SUNDRY NOTICES AND REPORTS ON WELLS

JOHN CHARLES

PERF AND FRAC THE CHACRA

CONDITIONS OF APPROVAL

JOHN CHARLES No. 7 PROPOSED COMPLETION

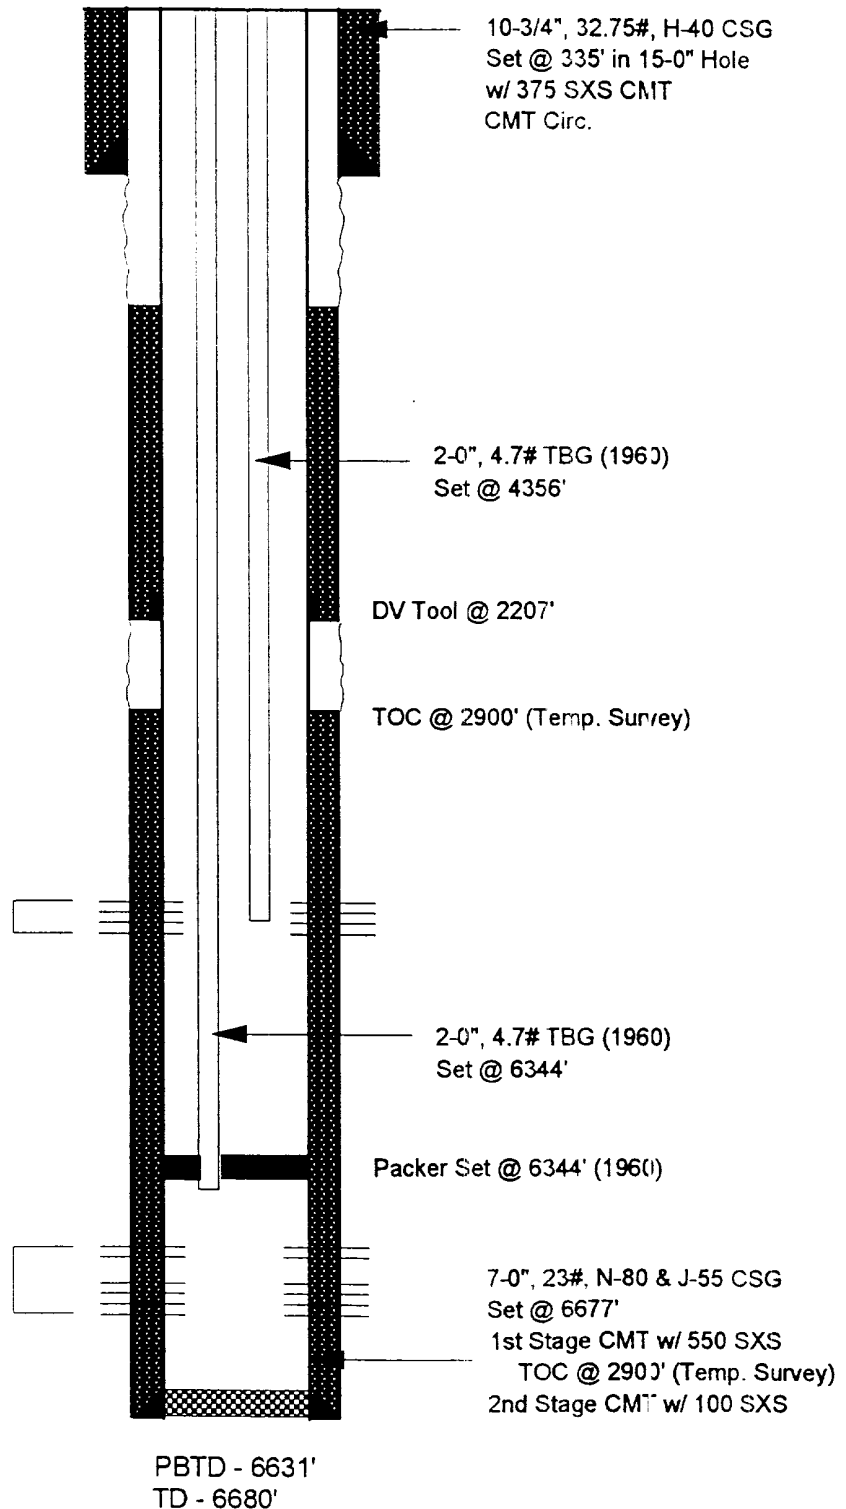
Need Chacra Plat NMOC
